HISTORIC AND DESIGN REVIEW COMMISSION

January 19, 2022

HDRC CASE NO: 2022-014
ADDRESS: 207 ROOSEVELT AVE
LEGAL DESCRIPTION: NCB A20 BLK LOT 6,7, 8 & PT OF A22 OR ARB P EXC S IRR 183.25 FT OF W 117 FT & 5 (.539 AC) & N HALF OF A20(LOT 13)
ZONING: I-1, H, RIO-4
CITY COUNCIL DIST.: 5
DISTRICT: Mission Historic District
APPLICANT: Mo Verdecanna/Alamo Architects
OWNER: Joe Bakke/KENEDY JUNCTION LTD
TYPE OF WORK: Construction of a commercial structure, site work, construction of a parking lot, exterior modifications to the 2-story historic structure, roof replacement on the 2-story historic structure, modifications to the 1-story mausoleum structure, construction of an accessory structure, entrance elements, exterior modifications
APPLICATION RECEIVED: December 30, 2021
60-DAY REVIEW: Not applicable due to City Council Emergency Orders
CASE MANAGER: Edward Hall
REQUEST:

South Roosevelt Development

Floor Plan

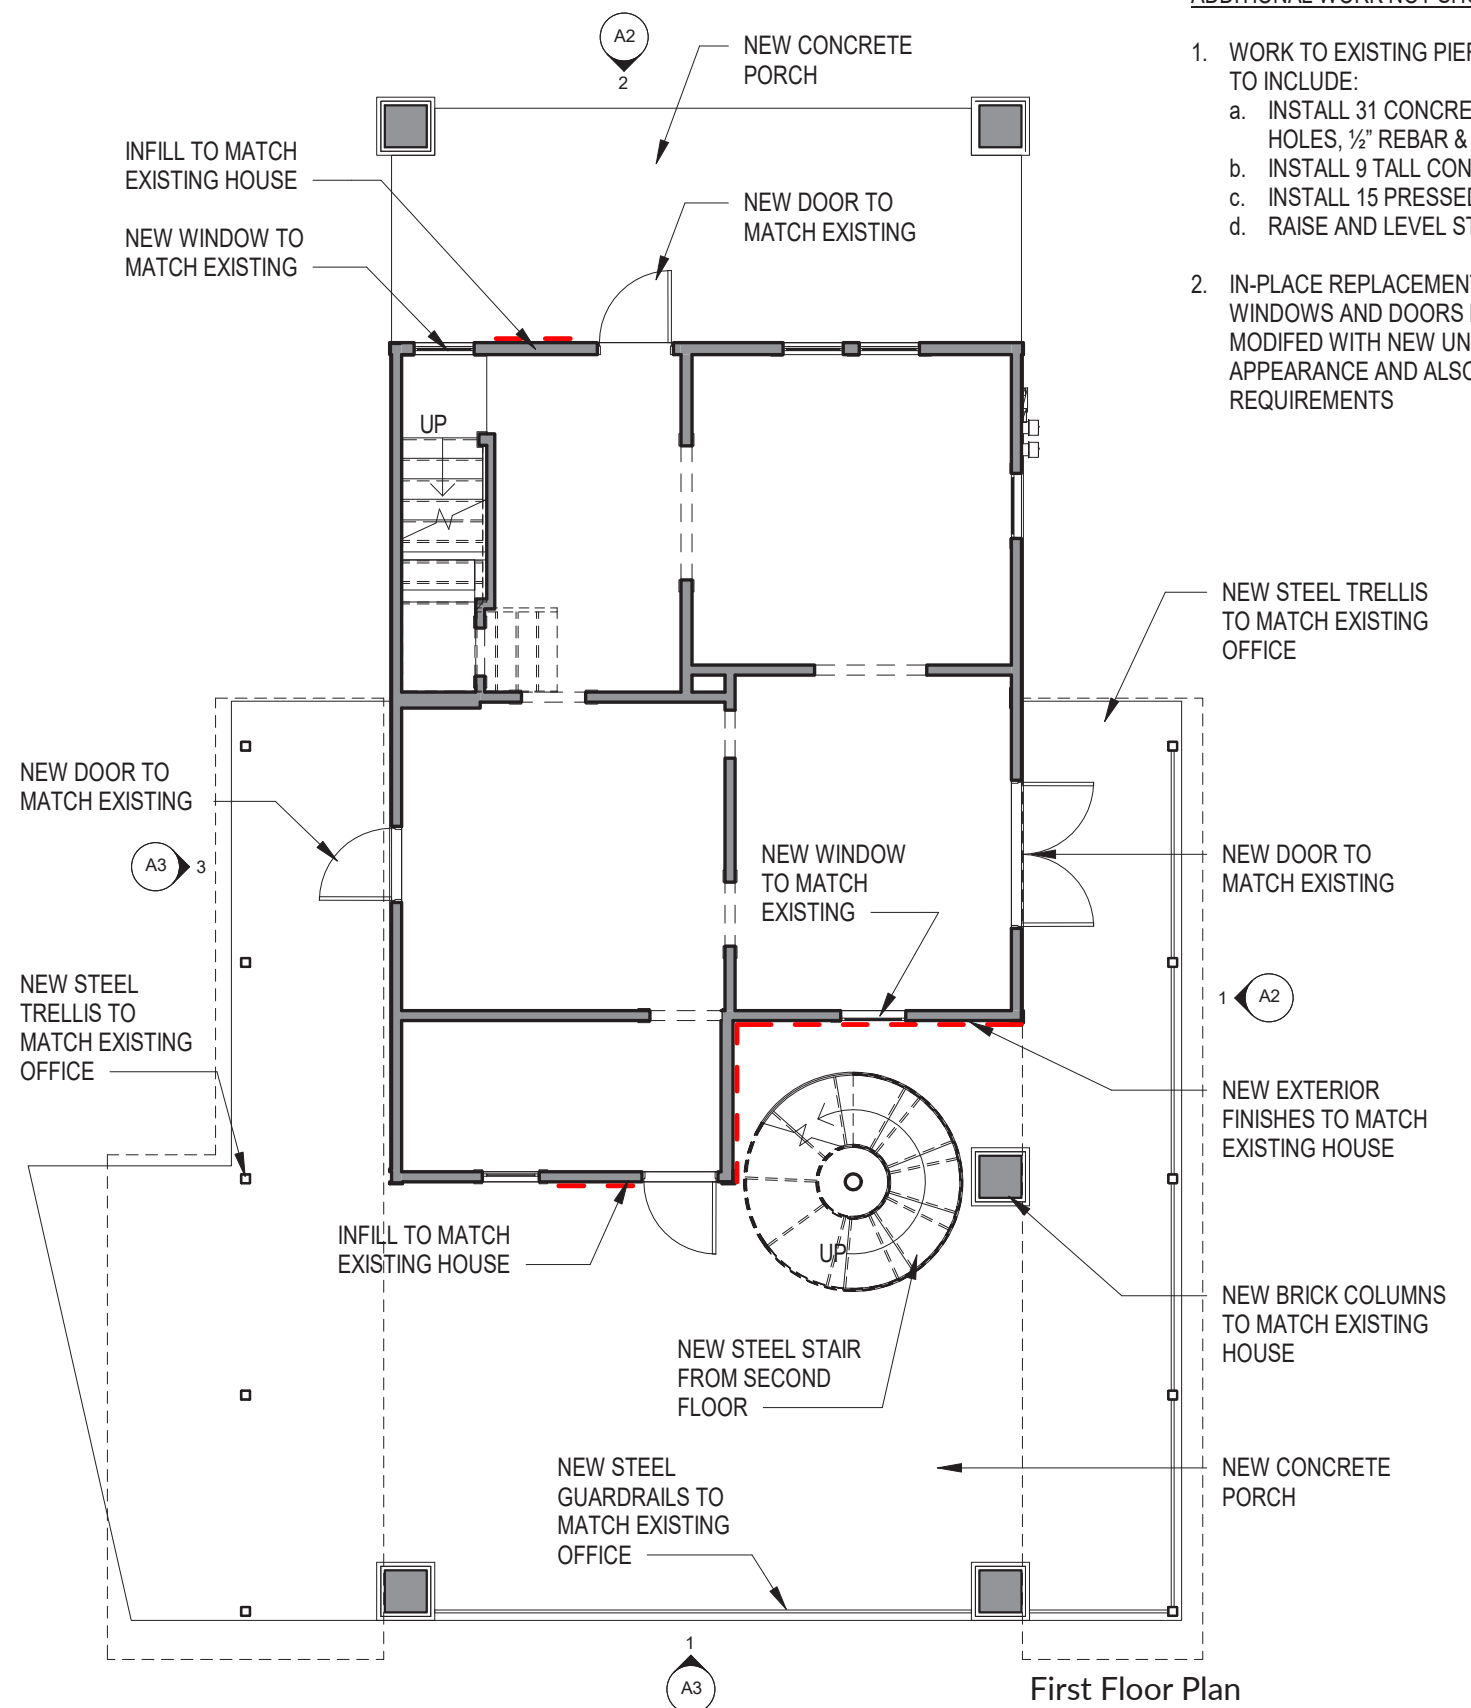
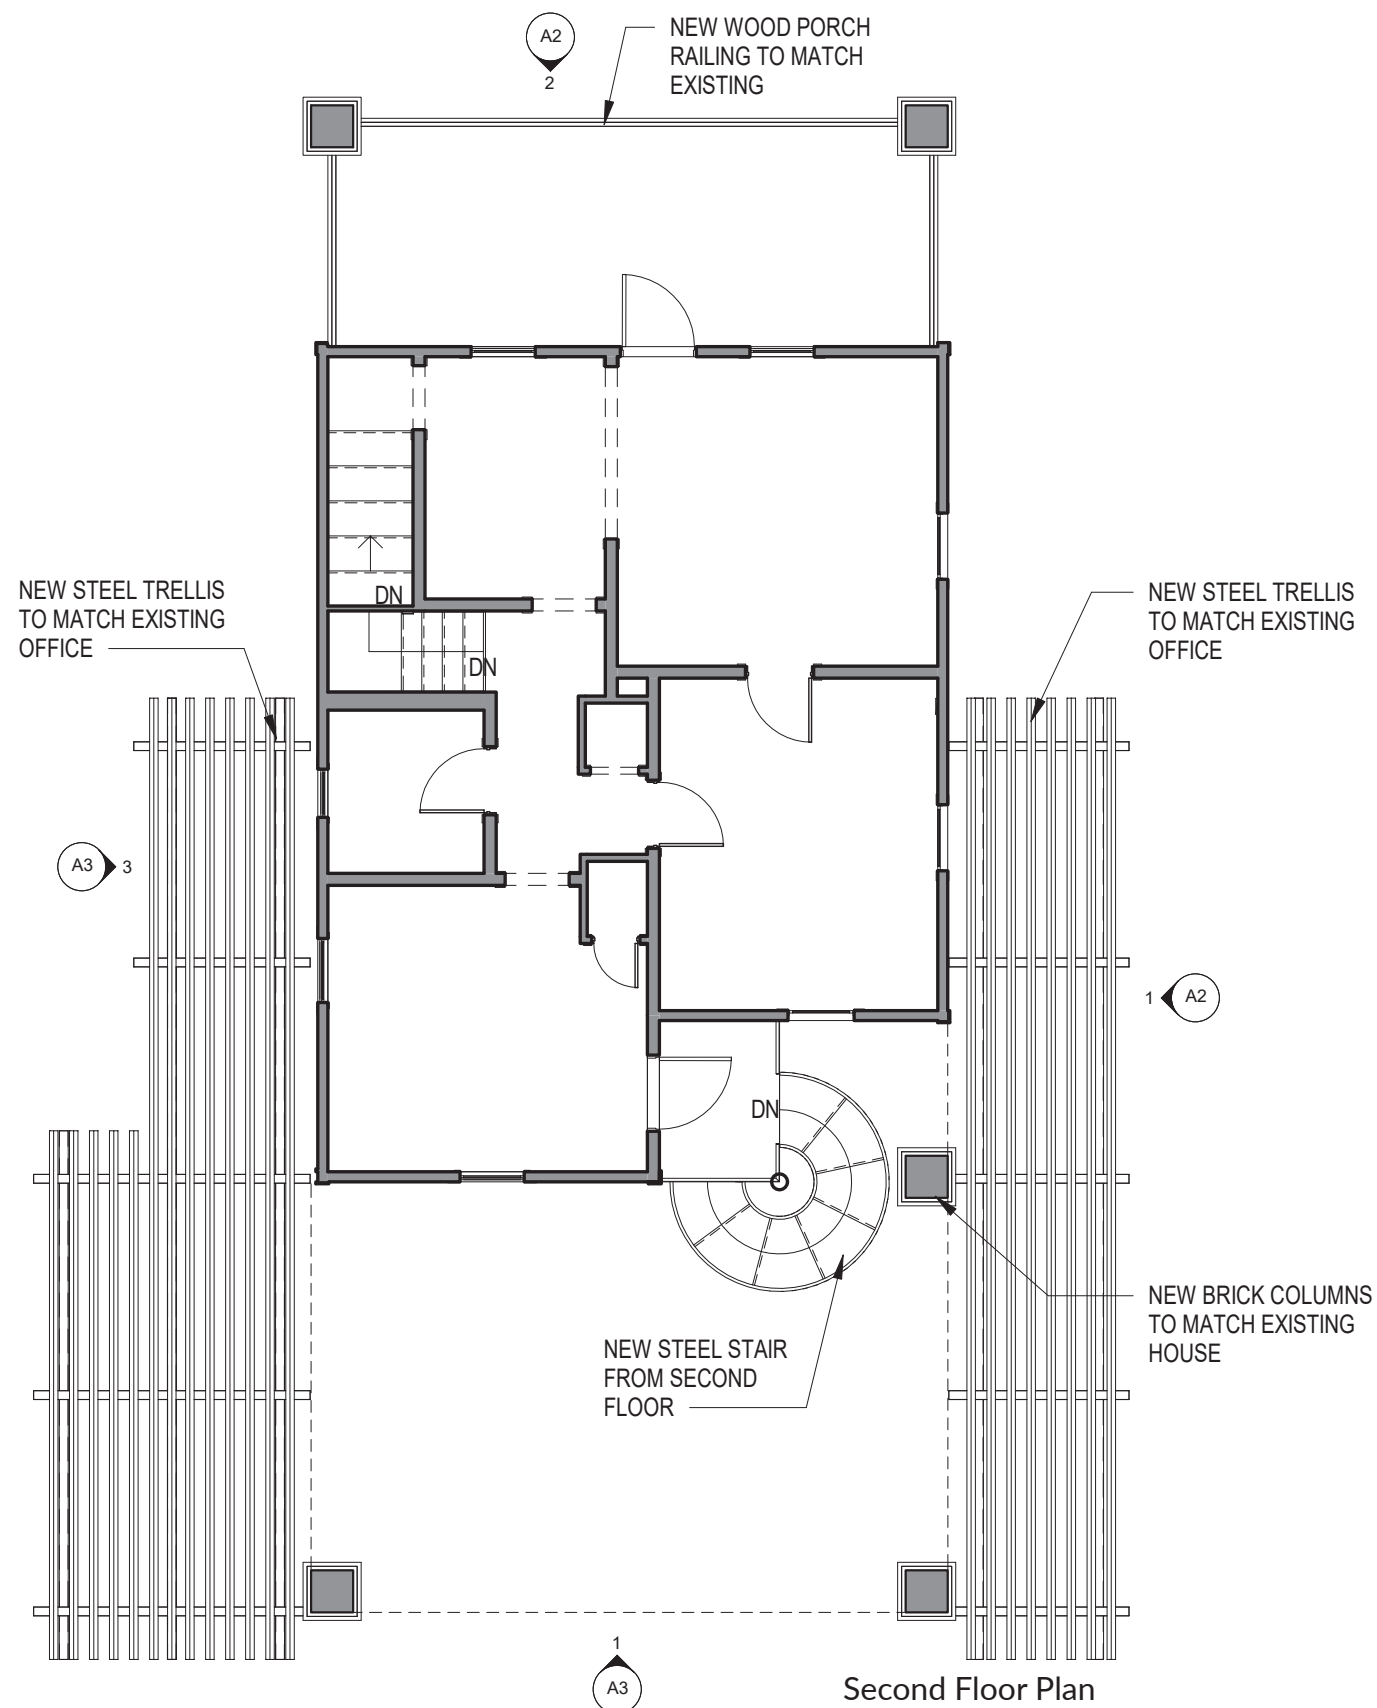
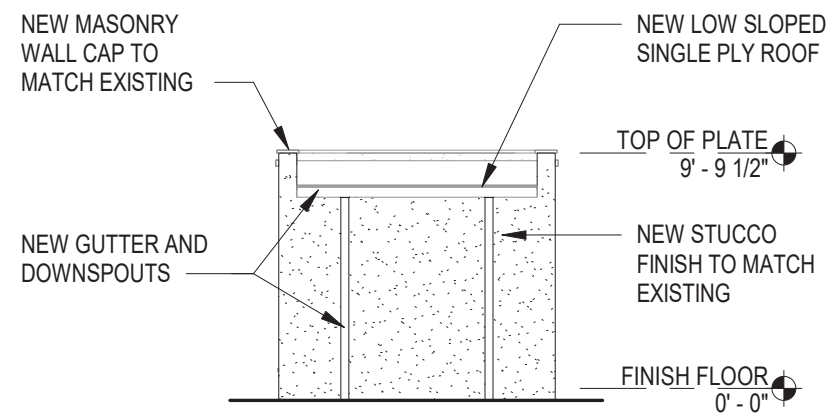
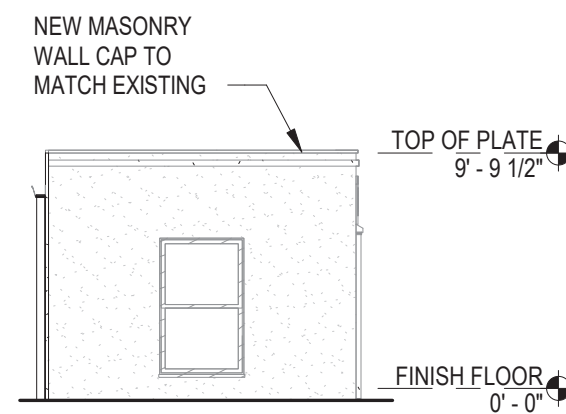
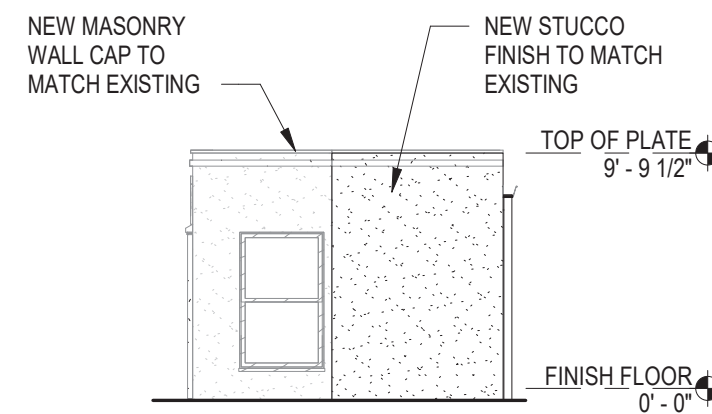
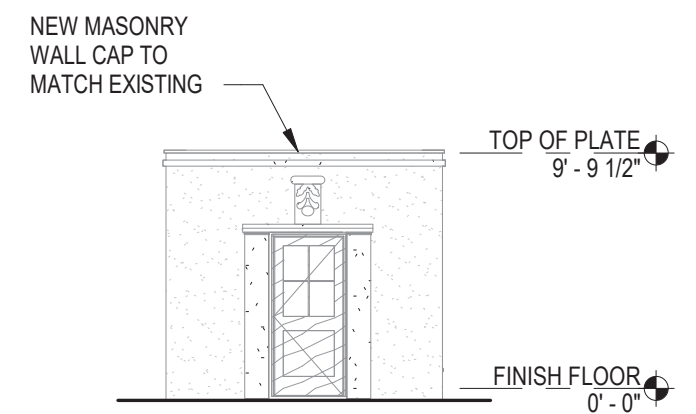
- o. **REMOVAL OF ADDITIONS** – The applicant has proposed to remove existing additions to both the north and south facades of the 2-story historic structure on site. The rear addition is not found on the 1951 Sanborn Map. Generally, staff finds the removal of these non-original additions to be appropriate; however, staff finds that the removal of these additions should be accompanied by an architecturally appropriate restoration. Fenestration patterns and façade arrangement should be consistent with the architectural style.

- p. **FENESTRATION MODIFICATIONS** – The applicant has proposed fenestration modifications to the historic, 2-story structure on site to include the removal of three, original, grouped windows for the installation of double doors on the south façade; the removal of two, non-original windows within the skirting location on the south façade; the removal of a window on the north façade for the installation of a door; the removal of a window on the west façade; and the removal of one window on the west façade within the skirting location. Per the Guidelines for Exterior Maintenance and Alterations 6.A.i., existing window and door opening should be preserved. Additionally, new entrances or window openings should not be created where visible from the public right of way. While staff finds the removal of windows within the existing crawl space/skirting area to be appropriate, original windows openings should be preserved. Additionally, staff finds the proposed creation of new entrances on both the north and south facades to be inconsistent with the Guidelines.

- q. **ROOF REPLACEMENT** – The applicant has proposed to replace the existing, shingle roof with a new, standing seam metal roof. Generally, given the Craftsman style of the structure, staff finds the installation of a standing seam metal roof to be appropriate. Panels should feature a width of 18 to 21 inches in width and a smooth finish with no striations and a standard galvalume finish. Seams should be 1 to 2 inches in height and the structure should feature a crimped ridge seam. No ridge cap should be installed.

- s. **REAR PORCH ADDITION CONSTRUCTION** – The applicant has proposed to construct a rear porch addition to feature two stories in height, brick columns, a spiral staircase and consist of the extension of the original structure's roof profile. Generally, staff finds the construction of an open air addition to be appropriate; however, per the Guidelines for Additions 1.B.i., additions should be subordinate to the principal façade of the historic structure in terms of scale and mass. Staff finds that the proposed rear addition should feature a subordinate ridge height.

- t. **TRELLIS STRUCTURE** – The applicant has proposed to construct a trellis structure on the north and south sides of the historic structure. The proposed trellis structure will be open air, and setback from the front façade. The proposed trellis structure will feature steel columns and guardrails. Generally, staff finds the proposed trellis construction to be appropriate; however, given its proposed connection to the historic structure, staff finds that it should be constructed of wood.

6. Staff recommends approval of item #6, modifications to the historic, 2-story structure including the removal of additions, rehabilitation, roof replacement and the installation of a trellis with the following stipulations:

- i. That modifications to the structure be consistent with the Historic Design Guidelines. Fenestration patterns and façade arrangement should be consistent with the architectural style.

- ii. That the proposed standing seam metal roof feature panels that are 18 to 21 inches in width, feature a smooth finish with no striations and a standard galvalume finish. Seams should be 1 to 2 inches in height and the structure should feature a crimped ridge seam. No ridge cap should be installed.

- iii. That the proposed rear addition should feature a subordinate ridge height. The original roof form should be distinguishable.
7. Staff does not recommend approval of item #7, the removal of existing window openings. Staff recommends all original window openings be maintained. Staff recommends that only window openings located within the crawlspace/skirting location be removed.
